# PERMIT

SEWAGE DISPOSAL SYSTEM

MARYLAND STATE DEPARTMENT OF HEALTH

SUBDIVISION Woodmark ROAD 12187 Rilland Court LOT 22, B.L. P. Sec. 11

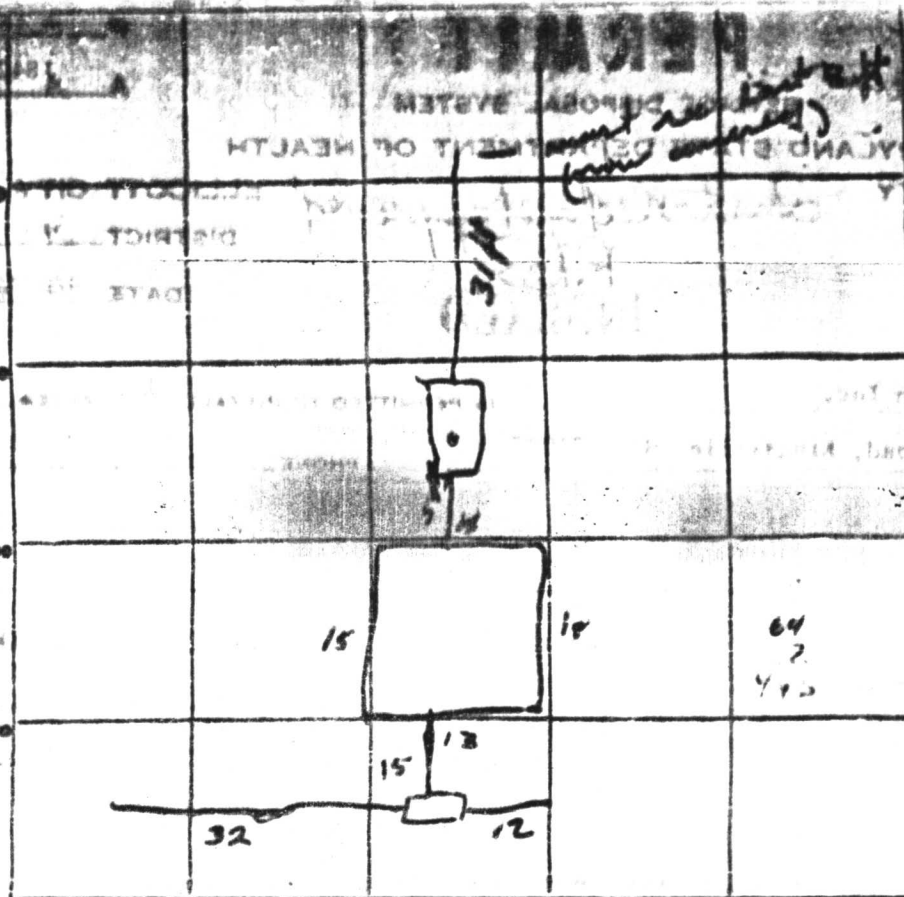
*not trench follow contour of ground*

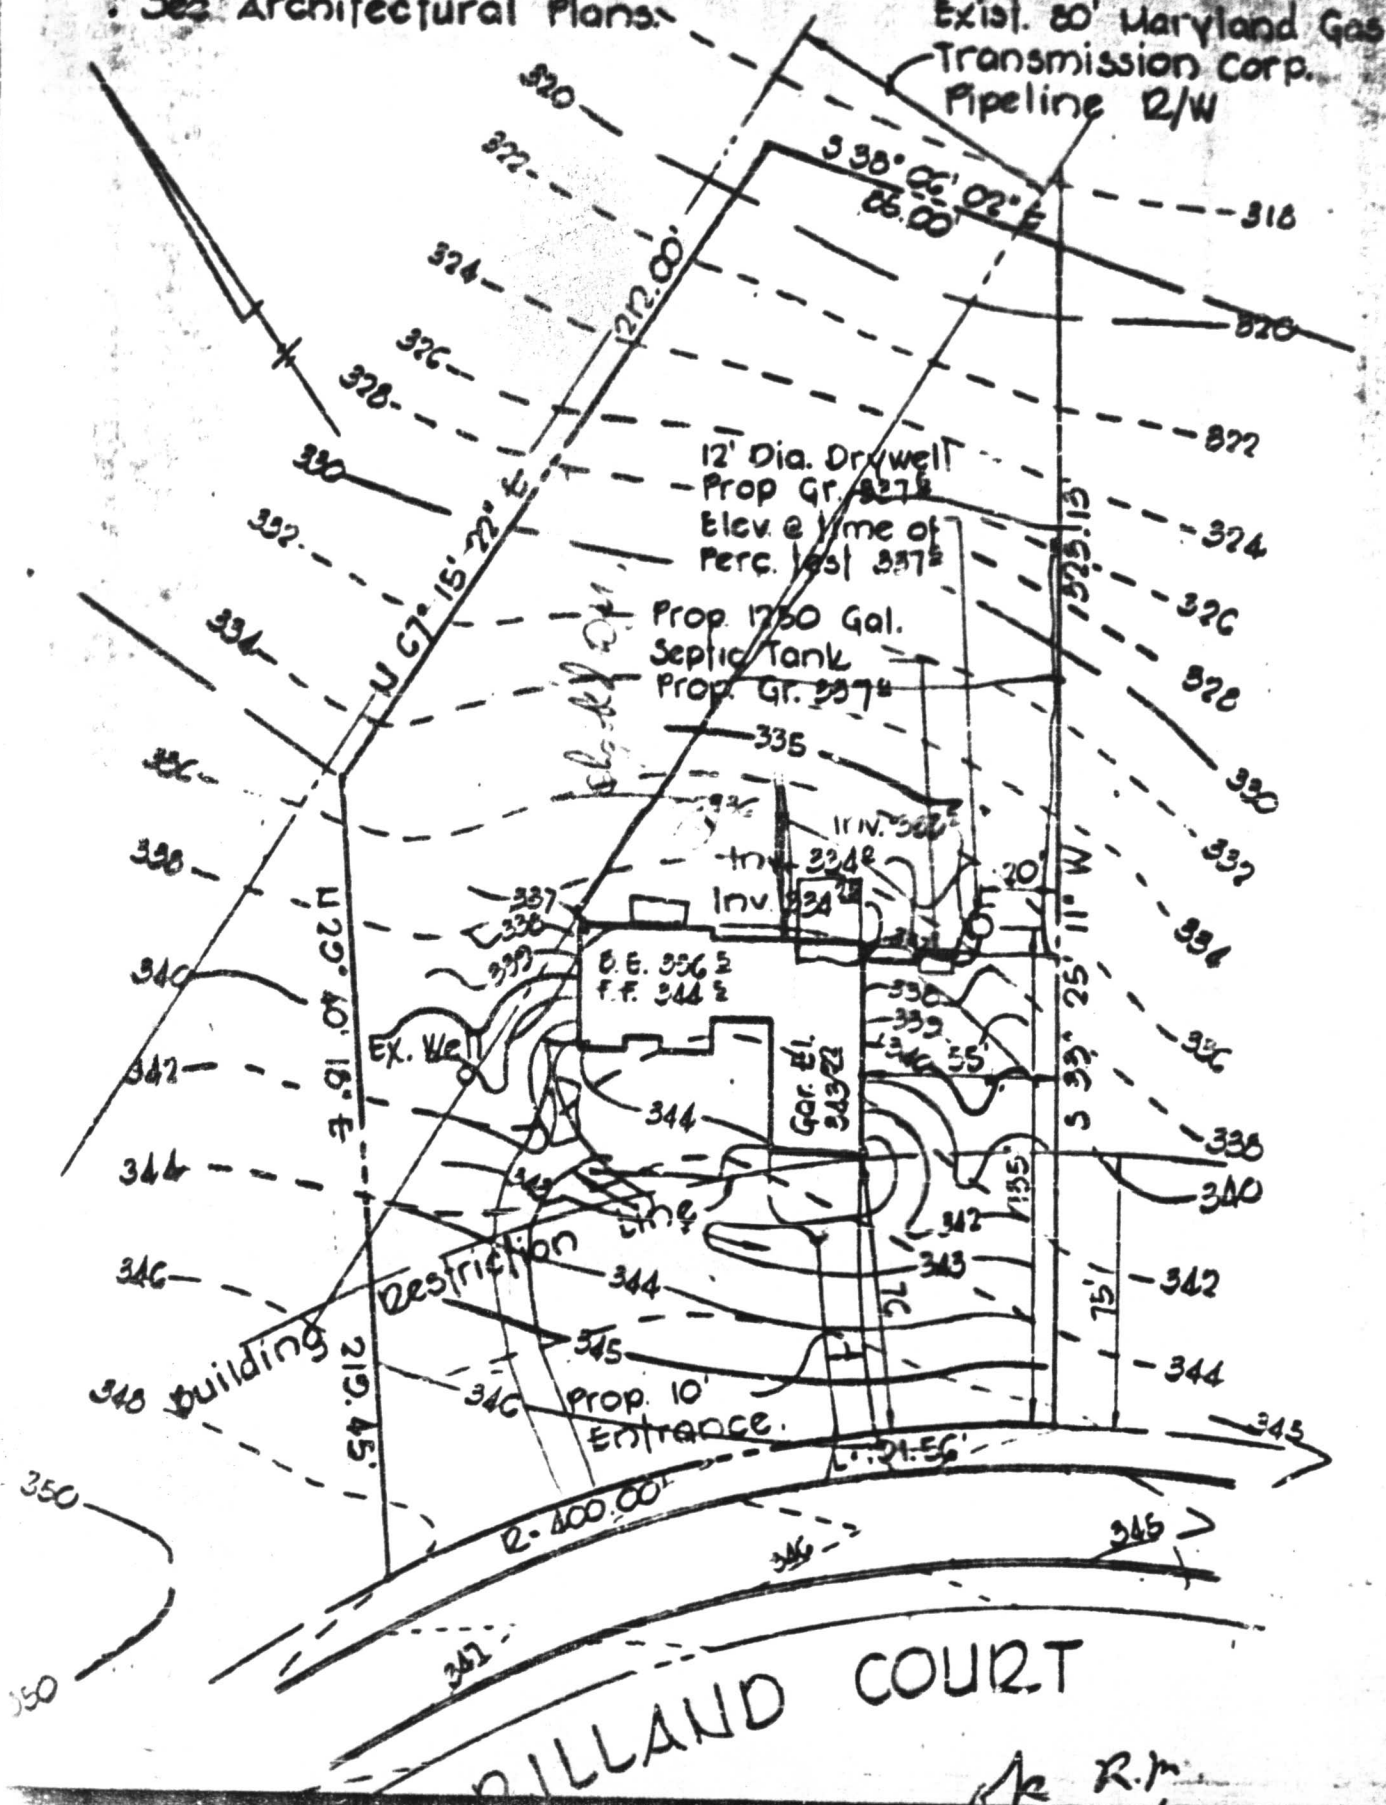
Unable to determine original grade and need  
to speak to DM about locations (conflict with  
specs and plan RAS 19 NOV 76. Add Manhole to  
septic tank C/O to dunnell shovel to trench

PLOT PLAN

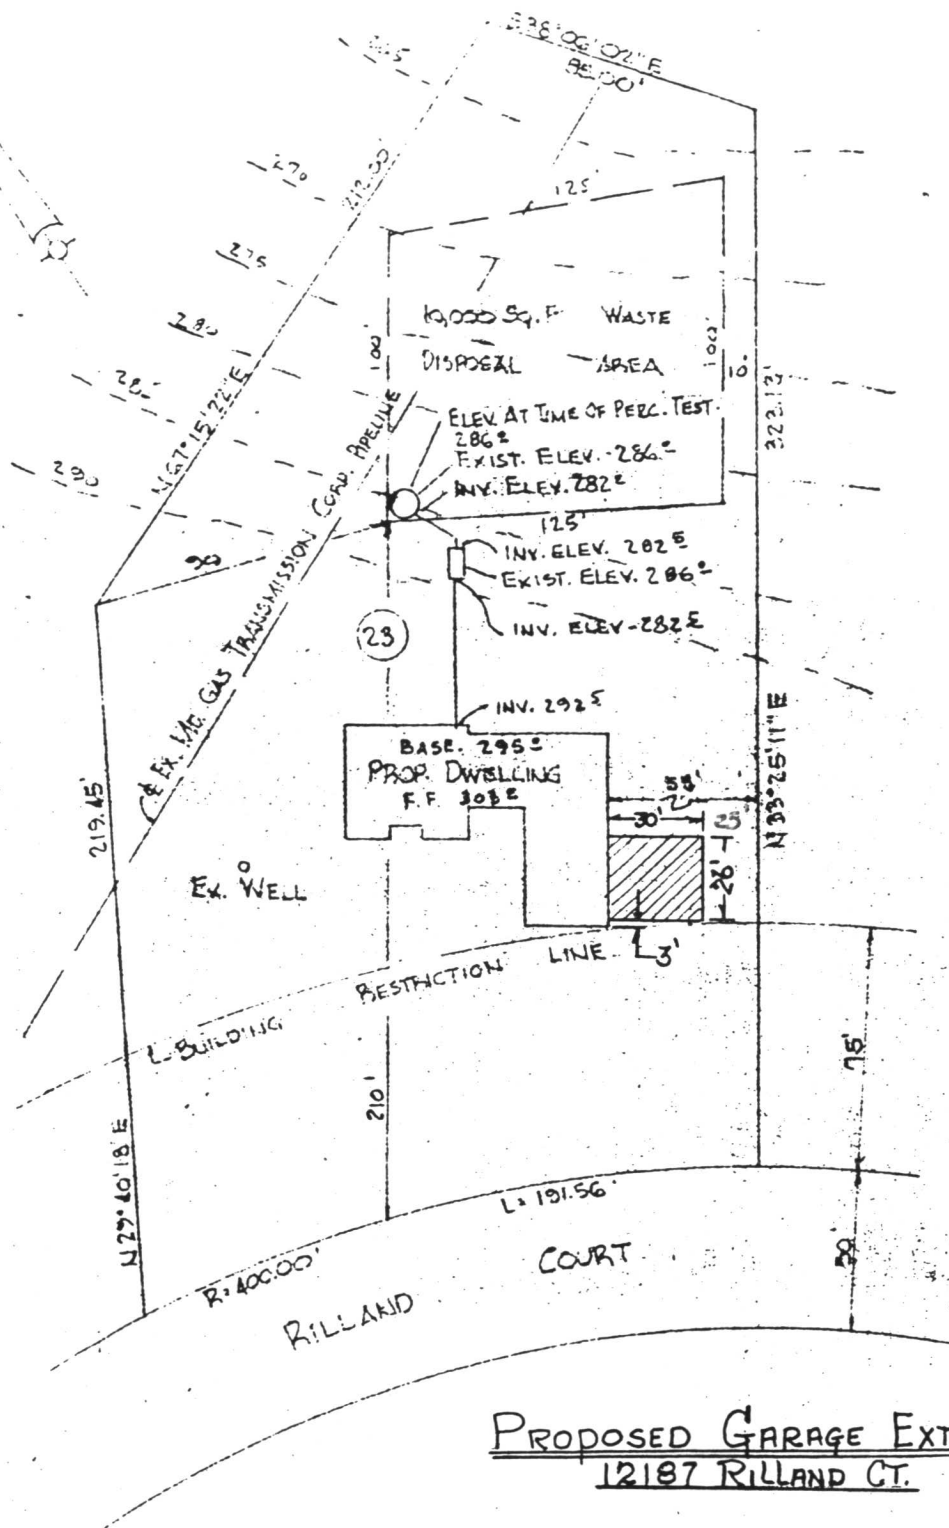
Proposed garage  
location OK  
as shown
